TITLE: **ANNEXATION NO. 12002,** requested by R.C. Krueger Development, to annex approximately 25 acres, more or less, generally located southeast of the intersection of South 70th Street and Yankee Hill Road.

PROJECT #: ***Annexation #12002***
Change of Zone #05068C - The Woodlands at Yankee Hill Planned Unit Development (PUD)

PROPOSAL: ***To annex approximately 24.16 acres of land*** and change the zoning designation from AG to R-3 PUD and to create approximately 64 additional lots for residential dwelling units.

UTILITY PLAN

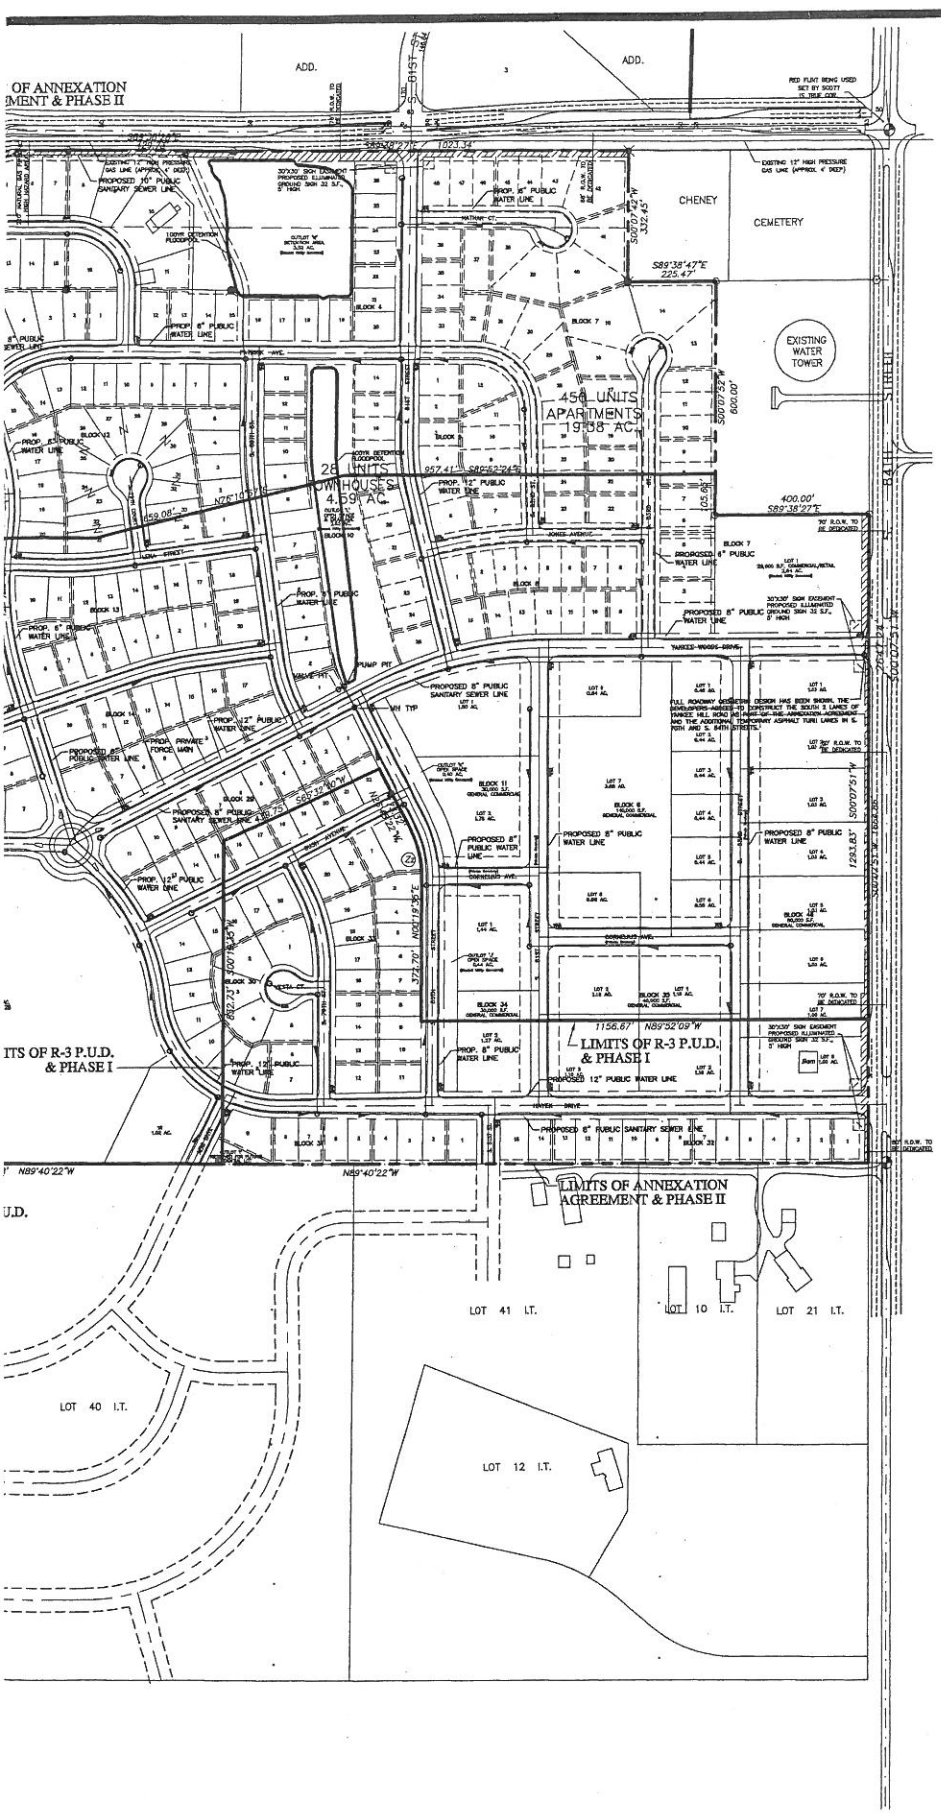
Public Works and Utilities also notes that while the 18" trunk sewer extending along the drainage is not required at this time to serve the area to be developed, it would be a significant disruption and hardship to the abutting lots on the east side of the drainage to install it after those lots have been developed. For this reason staff recommends the trunk sewer line be installed at the time the adjacent lots are final platted.

6. Public Works and Utilities noted additional corrections and revisions to the utility and grading and drainage plans. The requirement to make those corrections and revisions to the satisfaction of Public Works and Utilities is noted as a recommended condition of approval.

THE WOODLANDS AT YANKEE HILL
ANNEXATION & CHANGE OF ZONE EXHIBIT
'AG' TO 'R-3' P.U.D.

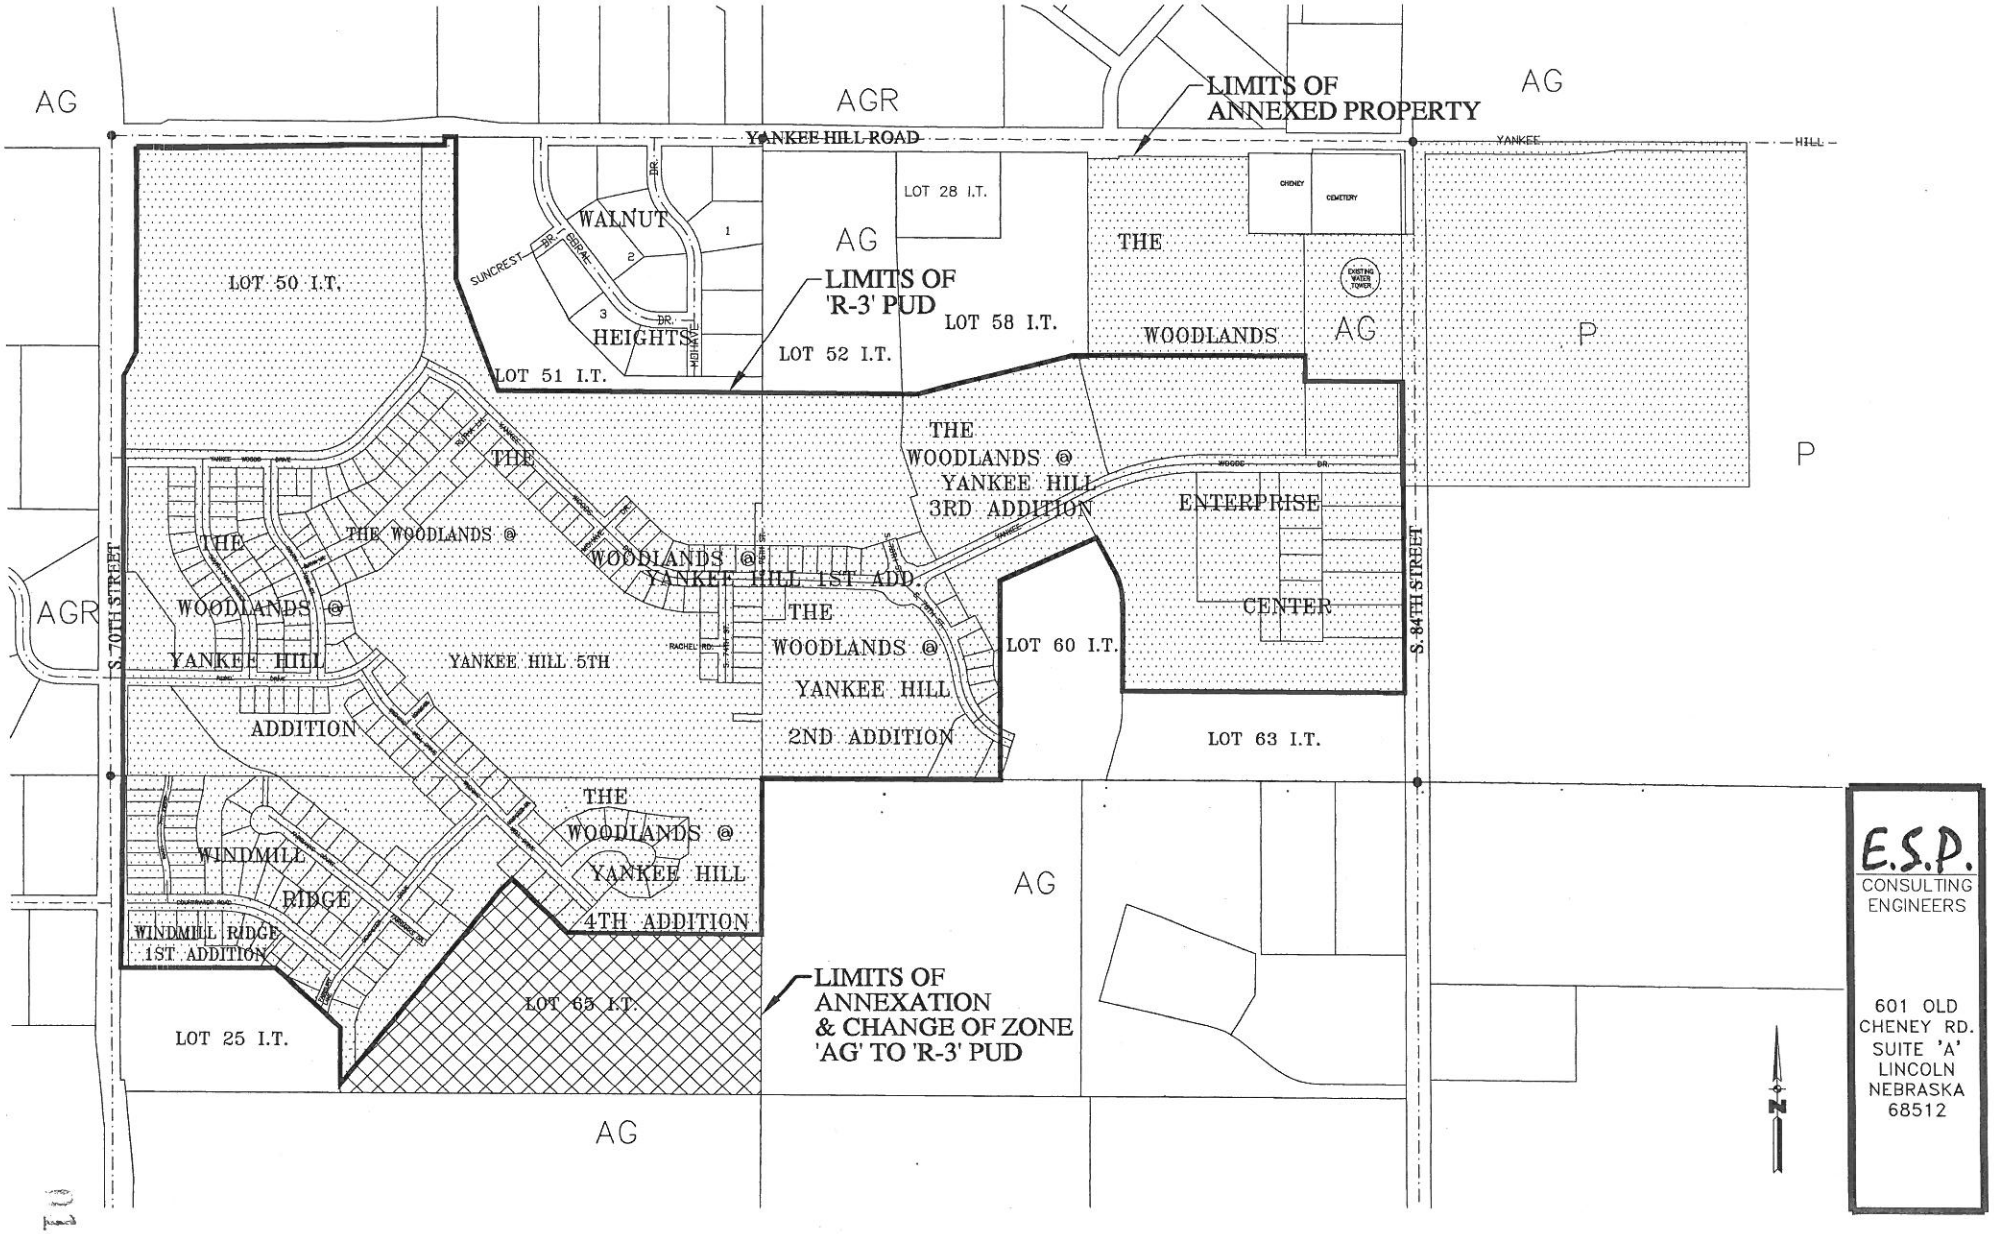
4. The Land Subdivision Ordinance requires the projection of street grades 300' beyond the boundary of a development. This is primarily to ensure that street connections with adjacent properties are practical, but also allows appropriate block lengths and pedestrian connections to be reviewed. Street projections are shown to the east, but the plans need to be revised to show street projections 300' to the south as well.

5. The Comprehensive Plan calls for a bike trail in this area, and it is shown on the plans next to the drainage which extends northwest to southeast across the middle of the site. The Parks and Recreation Department recommends the trail be located along the drainage, and that a platform be shown on the grading plan to accommodate it. Public Works and Utilities notes that a sanitary sewer easement is also shown in the same area, and from the information shown it is not clear whether the proposed grading plan adequately accommodates the facilities or not. Additional detail is required to determine the feasibility, and is included as a recommended condition of approval.
